## **Addendum # 3**

**Bid Opportunity: 25-7736-RFT**

**Waterloo-Oxford District Secondary School**

**ACE Classroom & Science Classroom Renovations**

REVISED SECTION DETAIL - 6/A5.01

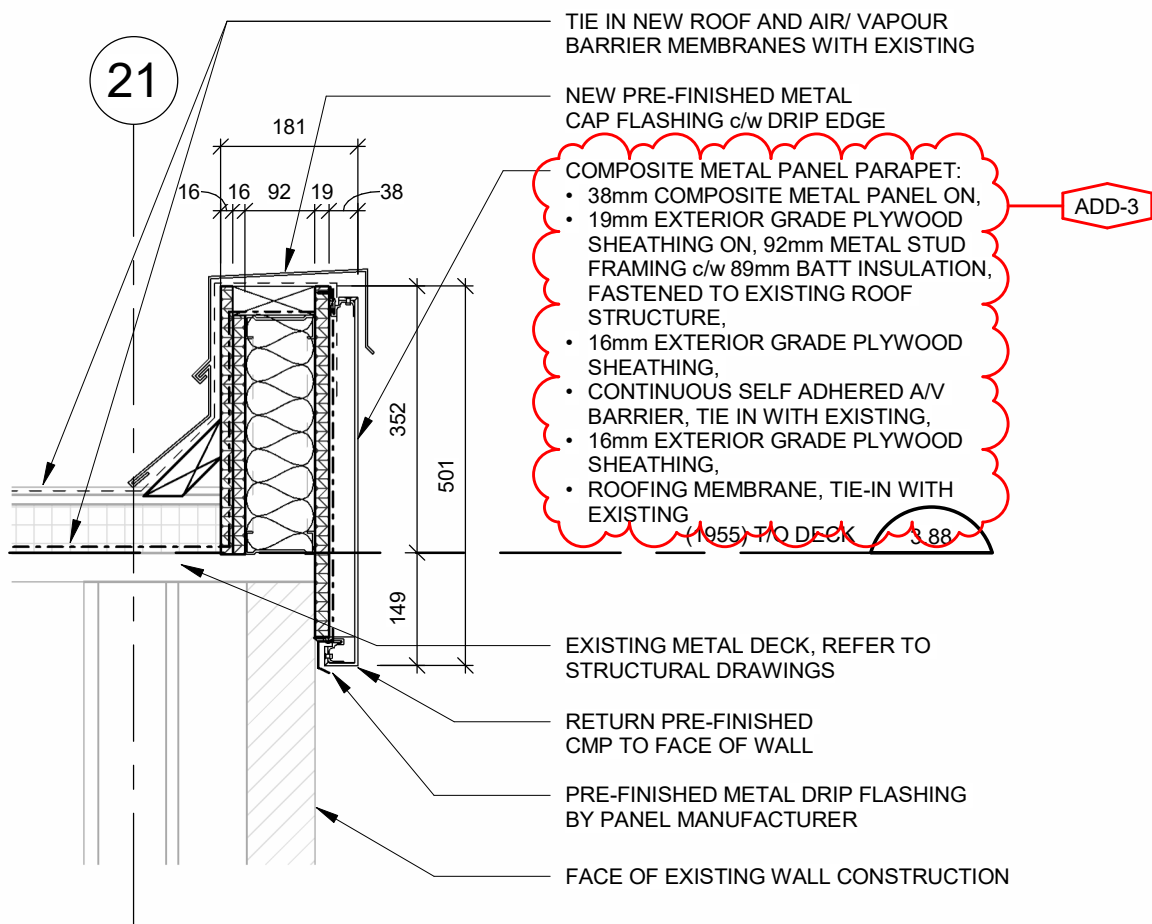
Detail 6/A5.01 indicates insulation in new parapet. Please clarify type and thickness required.

- .1 Drawing A0.01R Building Elements, Schedules, OBC Data, Typical Details, Abbreviations & General Notes
  - .1 ADD TYPICAL DETAILS FOR SERVICE TRENCHES, AS SHOWN ON DRAWING ASK.005, ATTACHED.
- .2 Drawing A5.01 Building Sections
  - .1 SECTION DETAIL 6/A5.01: REPLACE DETAIL WITH THAT SHOWN ON DRAWING ASK.006, ATTACHED.

REVISED NOTE ALSO APPLIES TO  
SECTION DETAIL 5/A6.01 AND 8/A6.01

**1 GROUND FLOOR DRAINAGE RENOVATION PLAN**  
 SK-M01 SCALE: 1:100

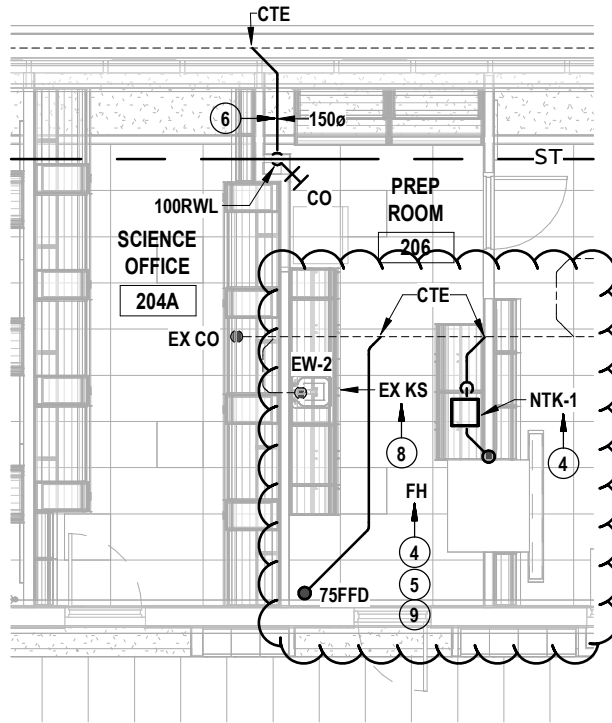
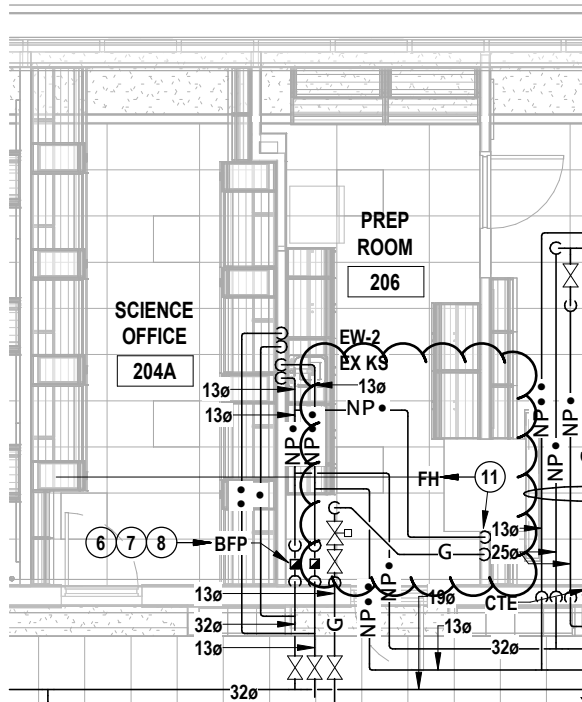
5. Reference drawing M3.1.
  - a. Revise detail 1 as per attached sketch SK-M01.
6. Reference drawing M3.2.
  - a. Revise note 1 to read, 'In Science Lab 208, temporarily remove and reinstall ex gas piping as required to support installation of additional piping.'
  - b. Revise detail 1 as per attached sketch SK-M01.
7. Reference drawing M3.3.
  - a. In detail 1, add notes 2 and 4 to radiant panel RP-4 in Prep Room 206.
8. Reference drawing M3.4.
  - a. In detail 1, Tech 200A and AV Office 200F, add note to read, 'Temporarily remove and reinstall one supply air diffuser, one return air grille and one exhaust fan as well as sprinkler heads to suit rooftop unit HVAC-17 structural reinforcing and associated removal and reinstallation of drop ceiling.'
